# DUTCH BROS. COFFEE - CO0707 - PEYTON, CO INITIAL EROSION CONTROL PLAN

INITIAL EROSION CONTROL PLAN  
 7520 FALCON MARKET PLACE  
 PEYTON, CO 80831

# DUTCH BROS. COFFEE - CO0707 - PEYTON, CO FINAL EROSION CONTROL PLAN

EROSION CONTROL DETAILS  
7520 FALCON MARKET PLACE  
PEYTON, CO 80831

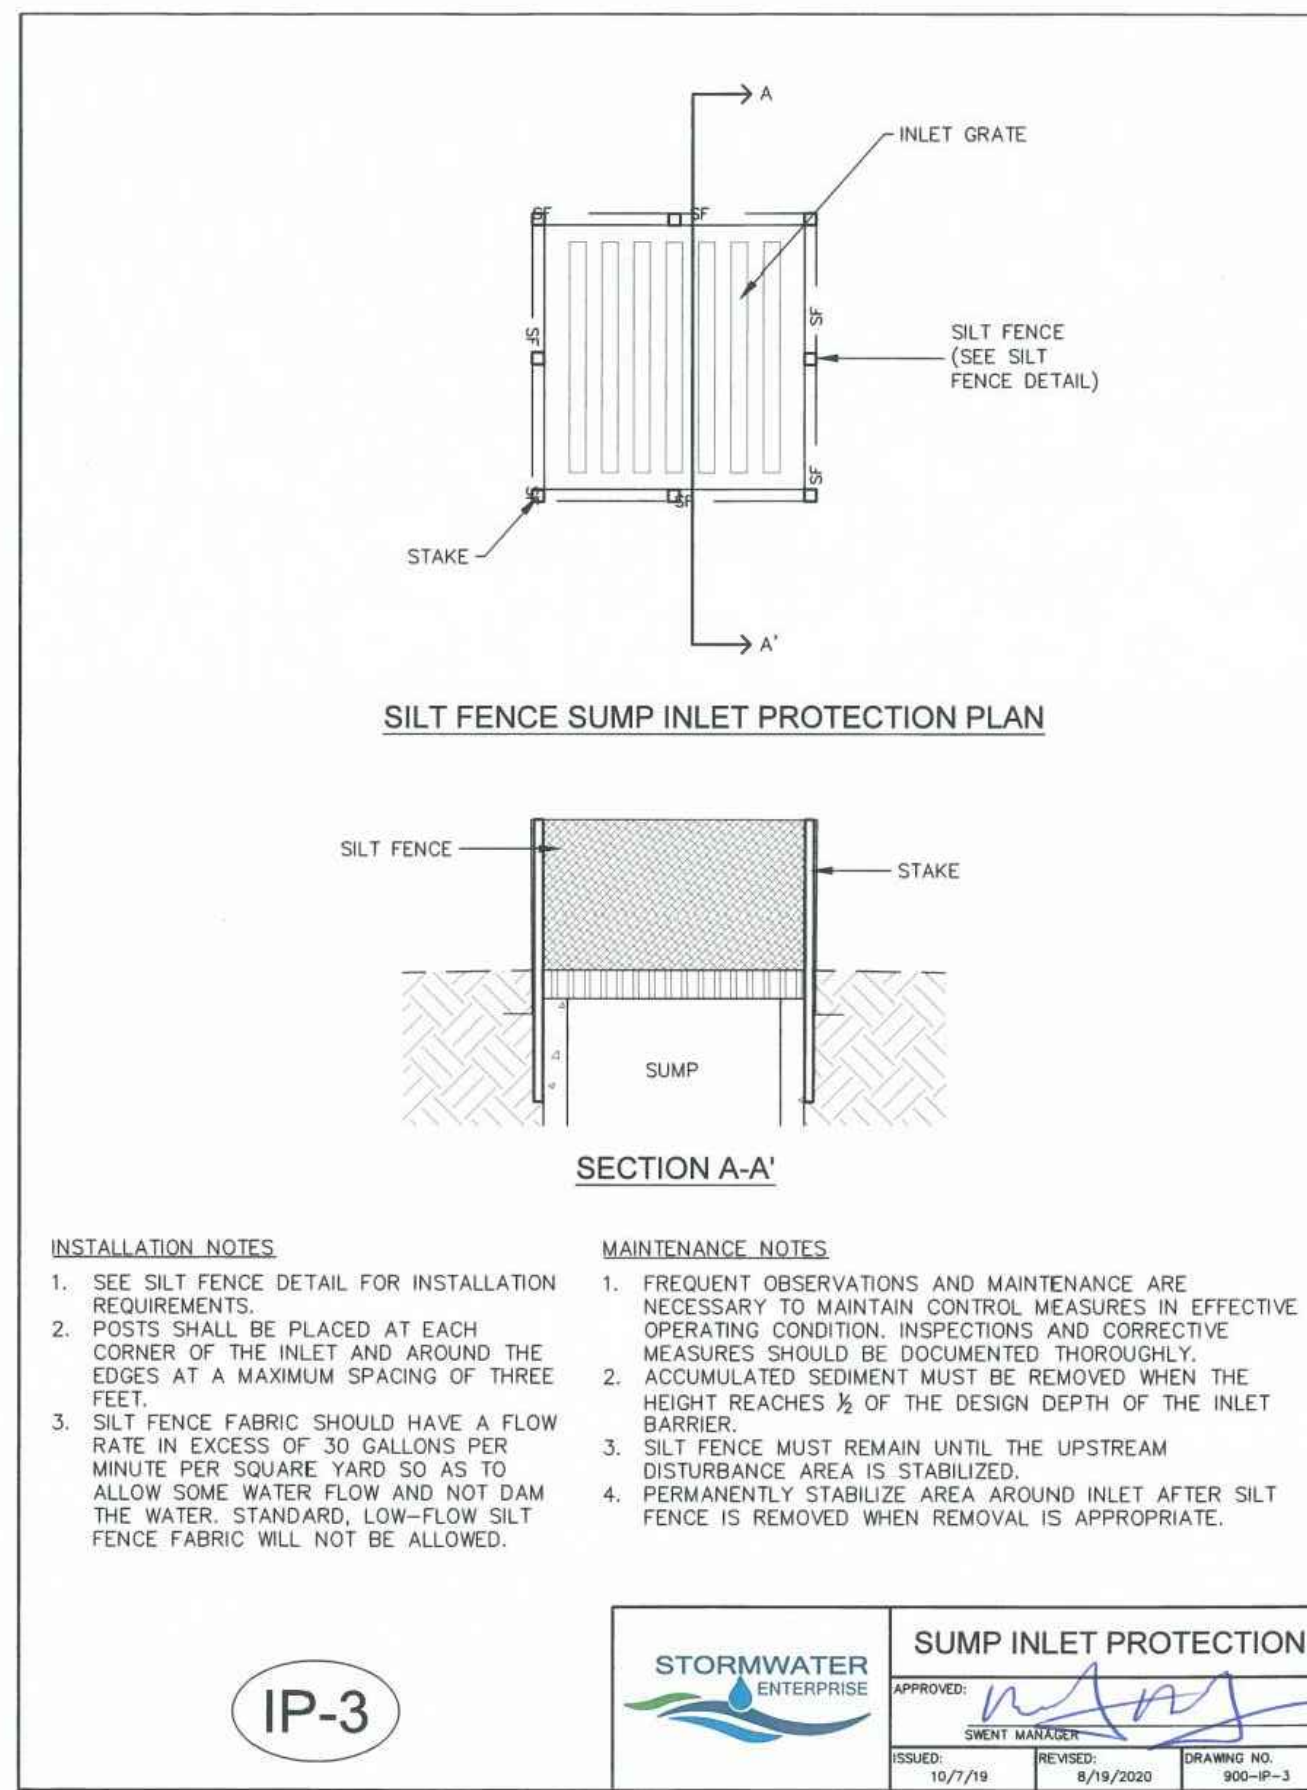
provide details for waddles and check dams
